# Comments from the Reviewers and the corresponding revision

## UNCERTAINTY REDUCTION AND PARAMETERS ESTIMATION OF A DISTRIBUTED HYDROLOGICAL MODEL WITH GROUND AND REMOTE SENSING DATA

by F. Silvestro, S. Gabellani, R. Rudari, F. Delogu, P. Laiolo and G. Boni

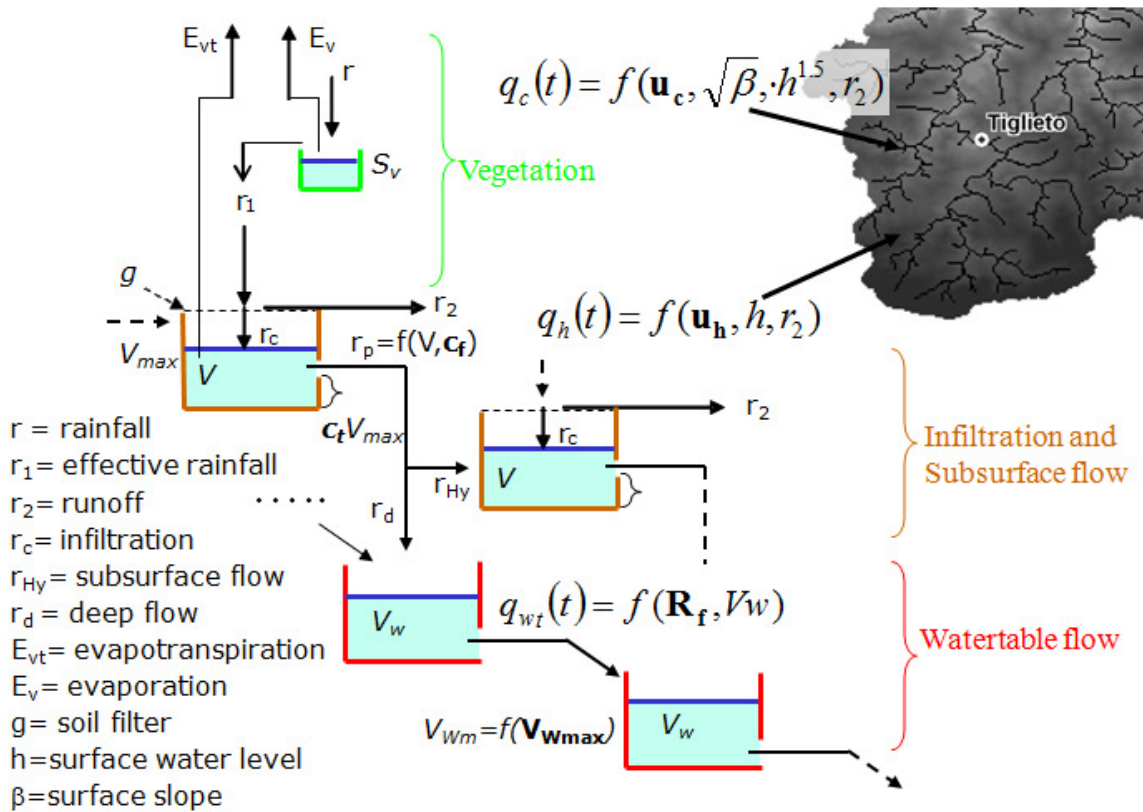
**Comment: A clear objective is missing from the introduction. Please indicate more clearly the objectives of this study.**

**Replay: We tried to rephrase the paragraph of the introduction in which we show the objective of the study:**

*“The objective of this work is to analyze the improved calibration skill of a distributed continuous hydrologic model by augmenting the model constraints with satellite-retrieved data. As a first analysis, in the context of a classical uncertainty analysis (Beven and Binley, 1992; Shen et al. 2012) it is shown that using satellite data together with ground stations observations can reduce the parameters’ uncertainty and equifinality. Than two simple calibration methods were developed and applied in order to exploit the advantages of utilizing multi-sensor observations. The first method lies...”*

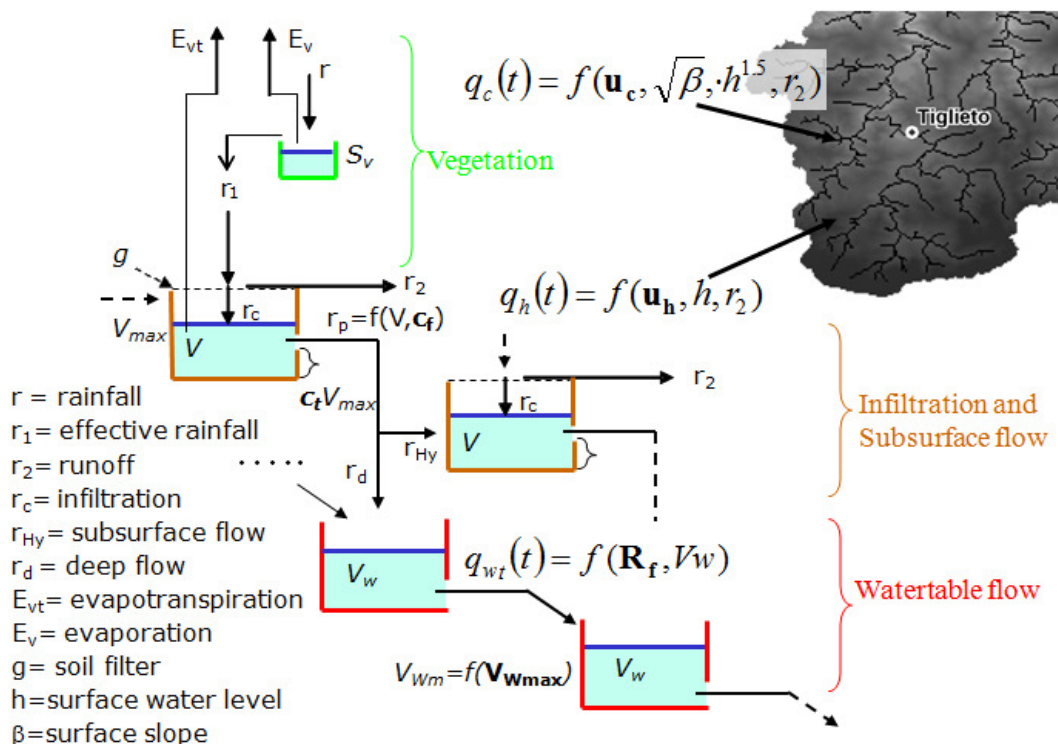
**Comment: Section 2: A Figure containing the set-up of the hydrological model would significantly help the reader to understand the text and the calibration process. Please include.**

Comment: The basic calibration parameters of the Continuum models should be presented and discussed in more depth. Table 1 presents the six calibration parameters of Continuum, with an indication of the physical process parameterized. However, I would have liked to see a deeper discussion of the physical meaning of parameters themselves. There are three adimensional parameters ( $c_f$ ,  $c_t$  and  $R_f$ ), but these are just numbers. I can speculate on the physical meaning of  $R_f$ , if it describes the ratio between vertical and horizontal conductivity, but I have no clue on the role of  $c_f$  controlling infiltration capacity at saturation or the role of  $c_t$  controlling field capacity. Likewise for the dimensional parameters: flow motion in hillslope is controlled by a parameter with units of inverse time while friction in channels is controlled by a parameter with more complex units. In order to properly understand the discussions, the reader should be presented with a detailed explanation of calibration parameters and their role on model equations. The authors state the Continuum is a distributed model, but calibration parameters are lumped. How are they related to the physical properties distributed over the basin? Do the same calibration parameters apply to forests, grassland and cultivated areas? How do their values affect, for instance, local soil properties? The author is referred to the original paper by Silvestro et al., 2013, but in that reference there is little discussion of the role of these parameters on calibration, which is the central topic of this manuscript. On section 4, four sources of remotely sensed data are presented, but it is not clear to me how Leaf Area Index data were used. Please explain.

Replay: We inserted a new figure with the set up of the model in the new version of the paper as suggested by the reviewer. See below

Caption: Representation of the different processes described in Continuum model and connection between cells. Surface flow is described by non-linear and linear equations respectively on channels and hillslopes.

Replay: In the new version of the manuscript we add more discussion about calibration parameters and their role. We also added a new figure (reported below), as suggested by reviewer 1, that represents the main setting of the model.
